Appeal of the Chief Building Official's Decision for a Sign Variance Application for Two First Party Wall Signs at 15-35 Mercer Street

Date: June 8, 2026
To: Sign Variance Committee
From: Project Director, Business Transformation, Toronto Building
Wards: 10 – Spadina-Fort York

Figure 1: Sign District of the Subject Premises and Surrounding Area

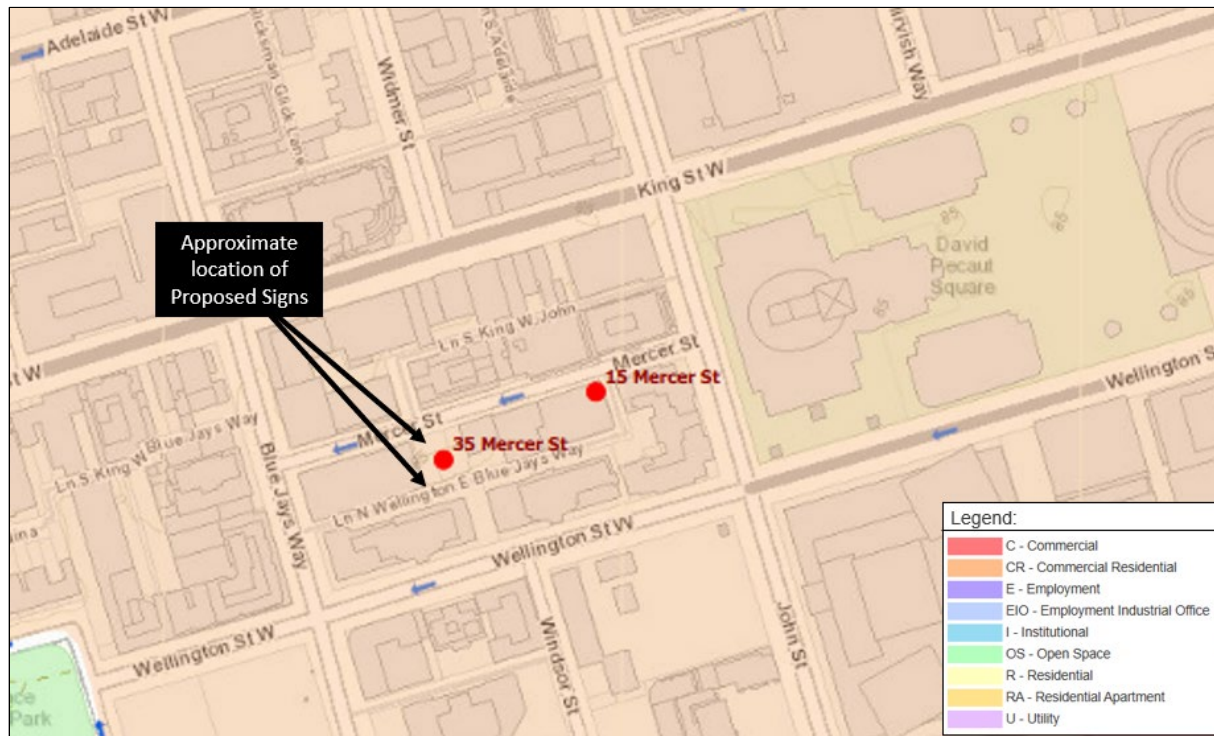
The Subject Premises is designated as a Commercial Residential (“CR”) Sign District. Wall signs of the first party class are permitted in CR Sign Districts, however, such signs are generally restricted to locations at or below the second storey of a building. The intent of these provisions is to promote pedestrian-oriented signage that supports the streetscape and assists with business identification at grade. In this context, signage is not intended to function as skyline-oriented branding or high-level advertising. An exception is provided for office buildings with 10 or more storeys, mainly to identify major tenants of high-rise office buildings.

Figure 4: Examples' locations in relation to the Subject Premises

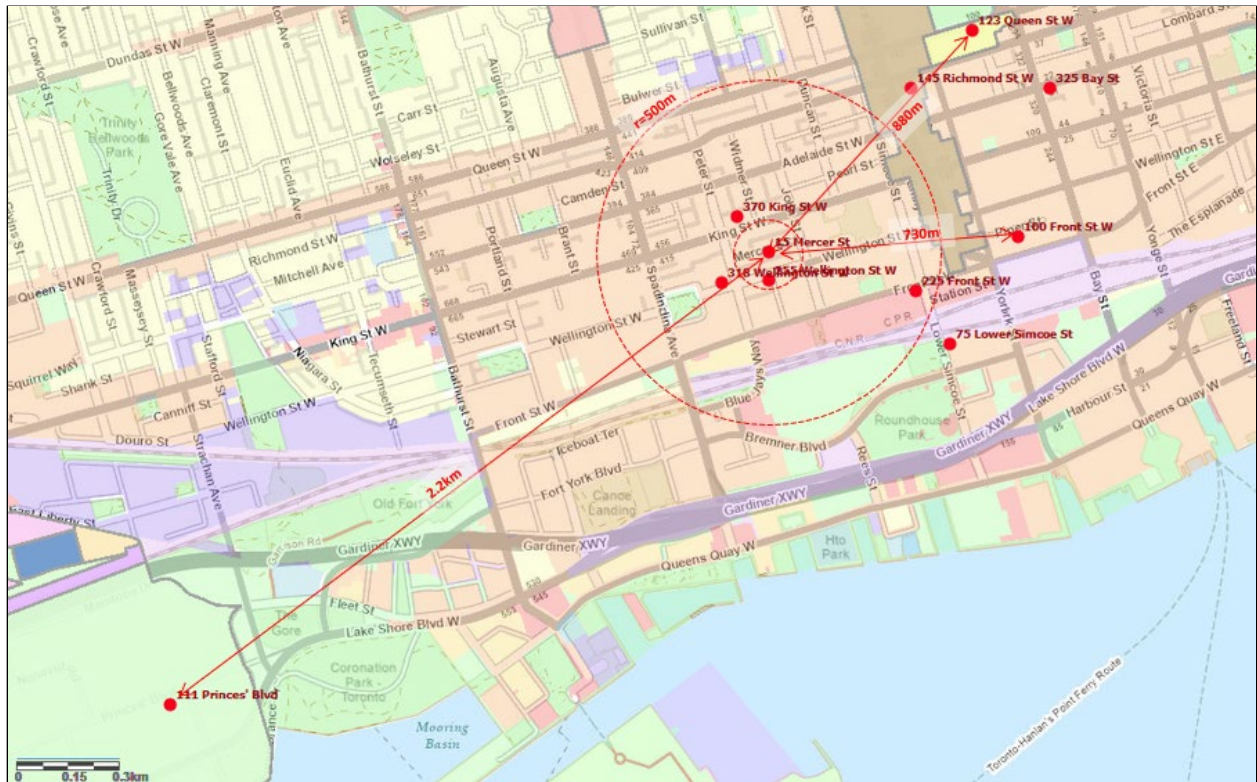
Furthermore, the examples provided by the Applicant are, in several cases, located at a considerable distance from the Subject Premises and outside the immediate context. As such, they are of limited relevance in assessing the character of the surrounding area or the appropriateness of the Proposed Signs at this location. The evaluation of variance applications must be grounded in the specific site context and applicable policy framework rather than broader or disparate precedents.

Figure 2: Secondary Plan Key Map

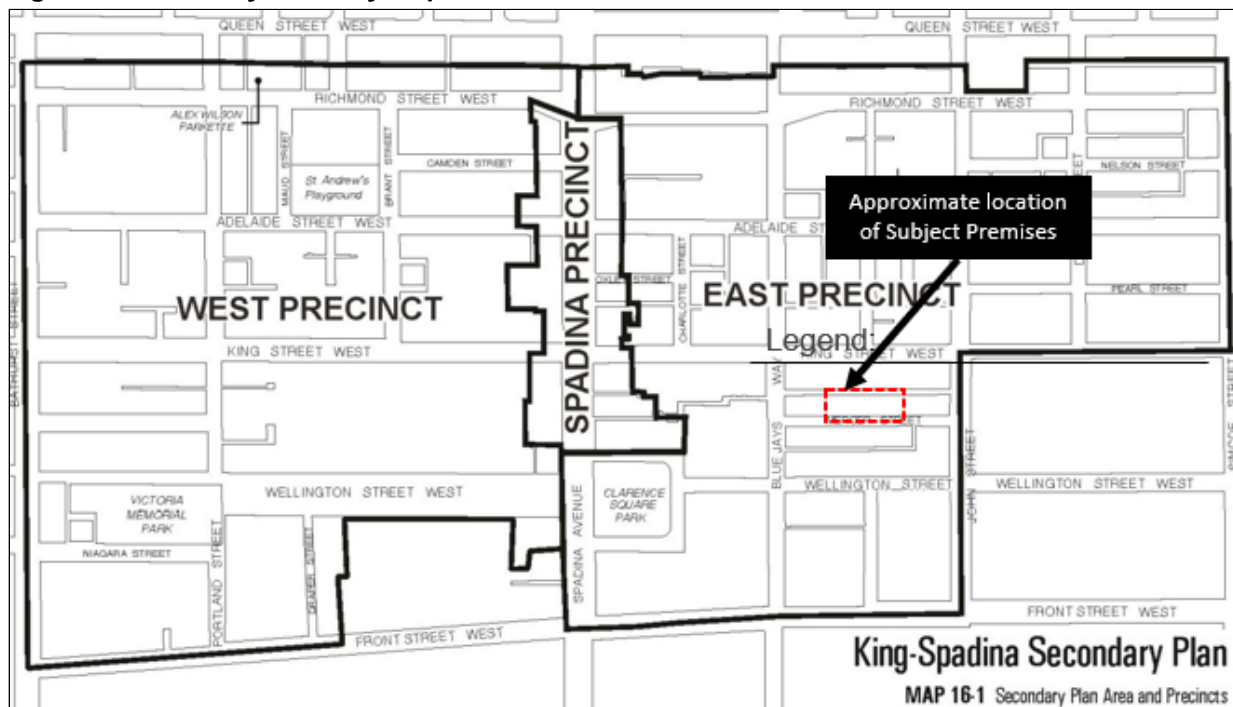
The Applicant identifies the Official Plan land use designation as Mixed Use Areas 1 within the King-Spadina Secondary Plan and Downtown Secondary Plan (Attachment 2, p. 13). Submissions outline general Official Plan objectives, including intensification, provision of a mix of uses (residential, hotel, retail, office), and support for economic vitality in the Downtown (Attachment 2, p. 13). While the rationale references these objectives conceptually, it does not cite any specific Official Plan policies that are supported by the Proposed Signs; rather, it relies on general alignment with mixed-use and economic development goals.
